Title - Sujet Cale Sèche Martha L. Black 2020	
Solicitation No. - N° de l'invitation F3065-201043/A	Amendment No. - N° modif. 011
Client Reference No. - N° de référence du client F3065-201043	Date 2020-05-08
GETS Reference No. - N° de référence de SEAG PW-\$QCV-018-17905	
File No. - N° de dossier QCV-9-42262 (018)	CCC No./N° CCC - FMS No./N° VME
Solicitation Closes - L'invitation prend fin at - à 02:00 PM on - le 2020-05-21	Time Zone Fuseau horaire Heure Avancée de l'Est HAE
F.O.B. - F.A.B. Specified Herein - Précisé dans les présentes Plant-Usine: <input type="checkbox"/> Destination: <input type="checkbox"/> Other-Autre: <input checked="" type="checkbox"/>	
Address Enquiries to: - Adresser toutes questions à: Piras, Gabriel	Buyer Id - Id de l'acheteur qcv018
Telephone No. - N° de téléphone (418) 956-2350 ()	FAX No. - N° de FAX () -
Destination - of Goods, Services, and Construction: Destination - des biens, services et construction:

**TITLE : CCGS Martha L. Black - Drydock Refit - 2020
Amendment 011**

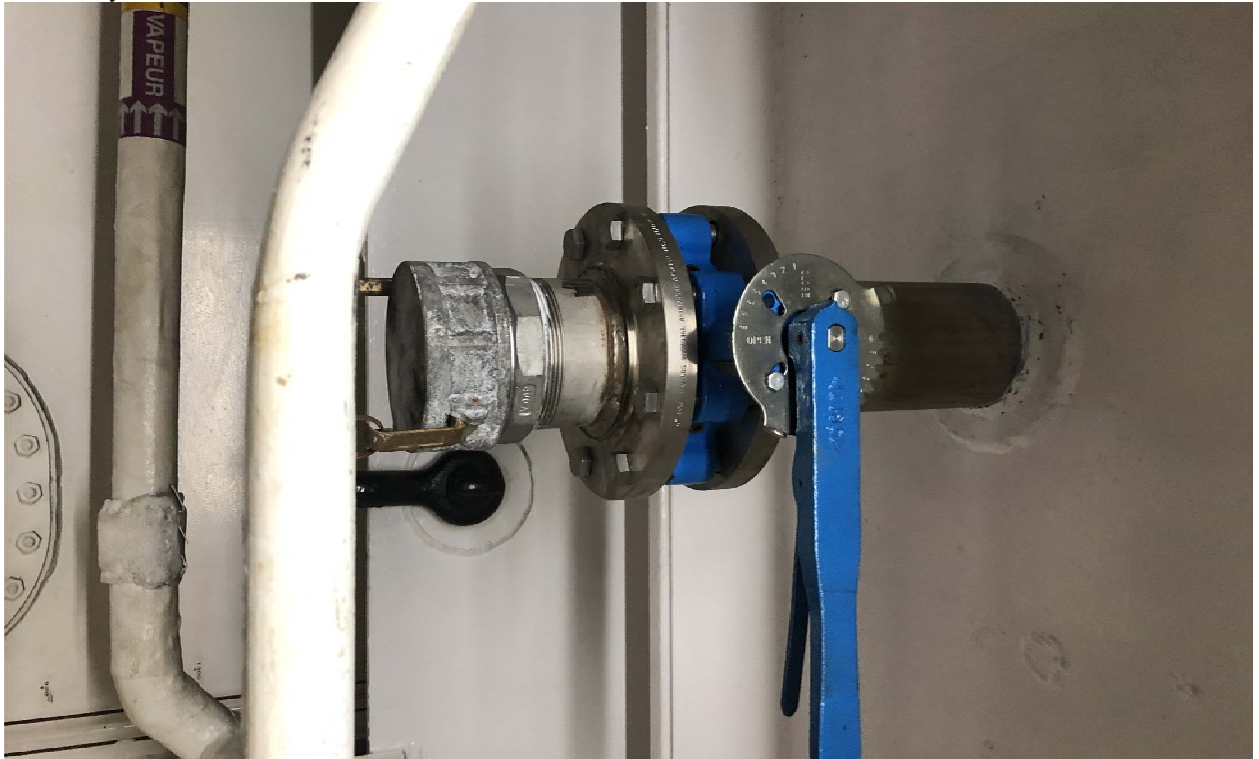
21.3.22 - Can you specify the type, size and quantity of valves to be treated in 21.3.22?

Answer : There are 4 valves attached directly to each tank:

1 globe 2" = drinking water pump suction (note: difficult to access on the port side; see photo)

1 globe 2" = filling valve

1 gate 2" = valve for level sensor (note: very difficult to access on port side; see photo)

1 butterfly valve 4 " = tank drain valve
